Comment Letter F – Gamst, Caroline

Response to Comment Letter F – Gamst, Caroline

Re: Pechanga Tribe Comments on the Draft Environmental Impact Report for Toscana Village at Temescal Valley, Plot Plan No. 26290, Conditional Use Permit No. 3712, General Plan Amendment No. 1146, Change of Zone No. 7859, EIR No. 552; SCH#2017071006

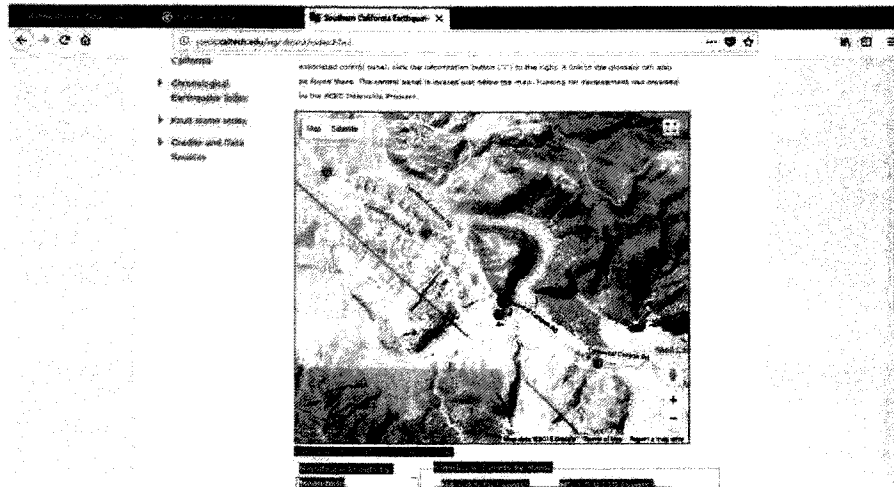
Please provide more detail on how you expect the synchronizing of lights to work to both Indian Truck Trail and Temescal Canyon Road at peak hour using a fully built out Terramor and fully operation Phase I and II.
- I-8 { **Car Trips Underestimated**

I am also very concerned that the Draft EIR may underestimate the number of car trips to the on and off ramps generated by the project at peak time. What percentage of customers were assumed would be also exiting the project at peak time? Many of these businesses are considered high volume and thus many trips at or before peak time would be thus round trips, exiting and reentering the freeway at peak time impacting ramp flow. Please provide more detail on expected traffic volumes entering or exiting, and whether or not a conservative factor was applied to it.

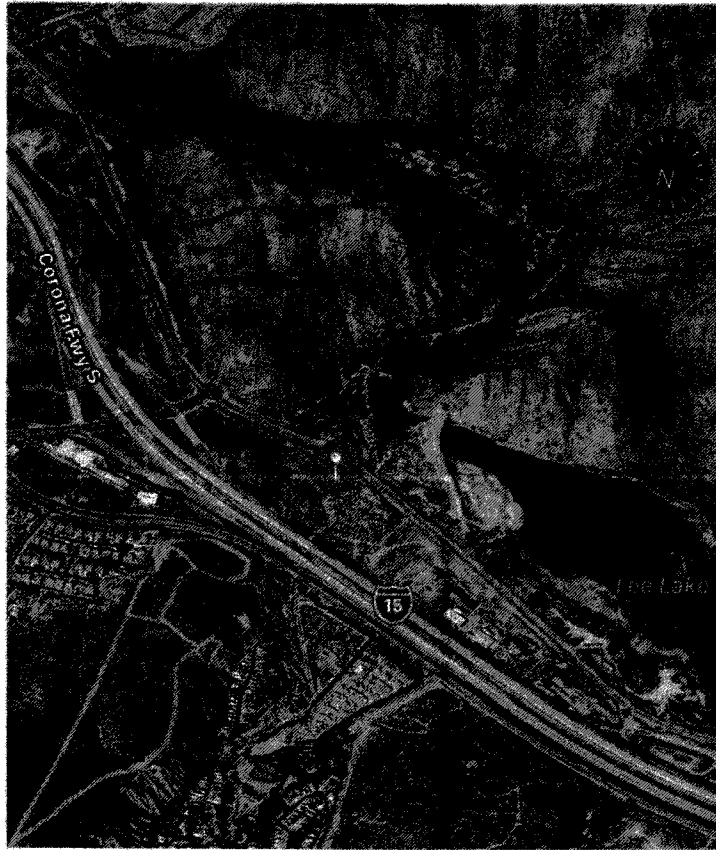
Please have the appropriate specialist validate that there are no concerns related to earthquake zone proximity.

This trace fault is shown east of and adjacent to the Project site in Figure 5 – Earthquake Faults in the IS/NOP Appendix A of the DEIR. The Elsinore Fault Zone and fault lines located southwest of the Project site are also shown in Figure 5 – Earthquake Faults in Appendix A of the DEIR. It is anticipated that the trace fault identified and evaluated in the Matrix Geotechnical Report and shown in Figure 5 of Appendix A of the DEIR is the same fault as identified in the California Institute of Technology map referenced by the Commenter.

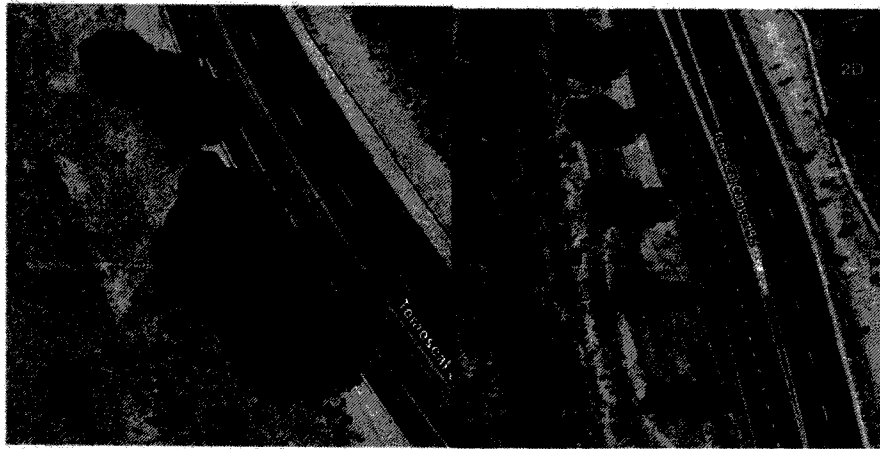
The Temescal Wash creates an impressive swath pinched between the Gavilan Hills and the Santa Ana Mountains. Although dry most of the year, the wash serves as an outlet for Lake Elsinore and eventually drains into the Santa Ana River. While the wash runs in a generally northwest/southeast direction, it also provides a critical perpendicular linkage for animals between the mountain and hill habitats on either side. That is why the wash plays such an important role in the Western Riverside County Multiple Species Habitat Conservation Plan.

The Project site is located within the Elsinore Area Plan of the Riverside County General Plan as shown in the DEIR Figure 3.0-4, Riverside County Area Plans. The Project site is directly adjacent to and southeast of the Temescal Canyon Area Plan with the project's northern boundary abutting the Temescal Canyon Area Plan boundary.

TCAP 5.12

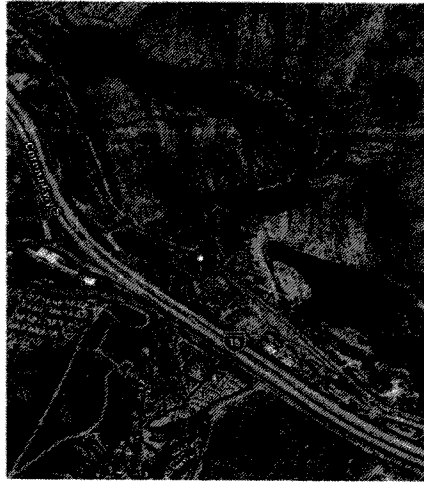
I would prefer to have the power lines put underground in this scenic area. The Terramor development on the other side of the road improved the aesthetics of the area and relocating the lines above ground to a new spot would seem inconsistent with nearby improvements on this historic road, and inconsistent with Temescal Canyon Area Plan guidelines for putting powerlines underground whenever feasible near washes or streams.

Discourage utility lines within the river corridor. If approved, lines shall be placed underground where feasible and shall be located in a manner to harmonize with the natural environment and amenity of the river.
